## PCI-SIG ENGINEERING CHANGE NOTICE

<b>TITLE:</b>	Protocol Multiplexing
<b>DATE:</b>	June 17, 2010
<b>AFFECTED DOCUMENT:</b>	PCI Express 3.0 Revision 0.9
<b>SPONSOR:</b>	AMD, HP

**Figure 3-13: TLP Following Application of [TLP](#) Sequence Number and Reserved Bits**

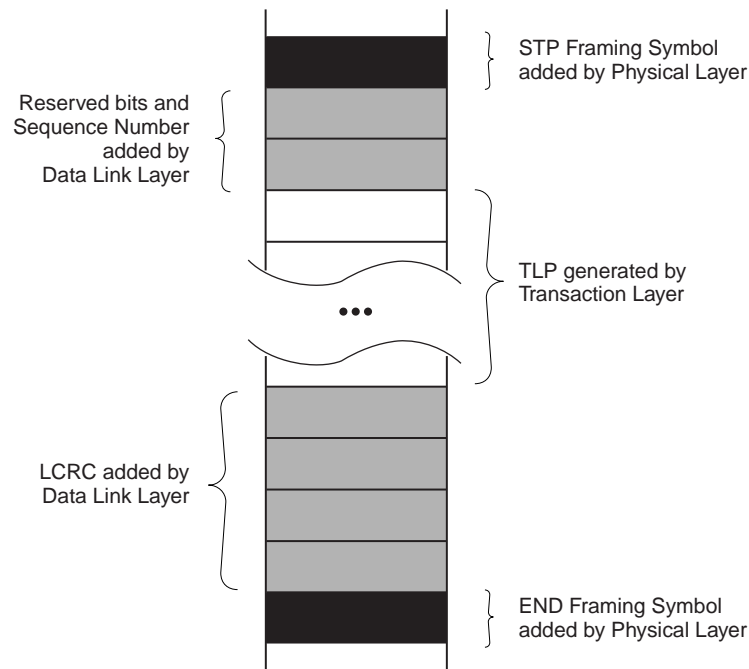
Modify Figure 3-13 in Section 3.5.2.1 as follows:

Editor: in Figure 3-13, change Symbol +0, Bits 7:4 so it has Bits 7:4 containing 0000b.
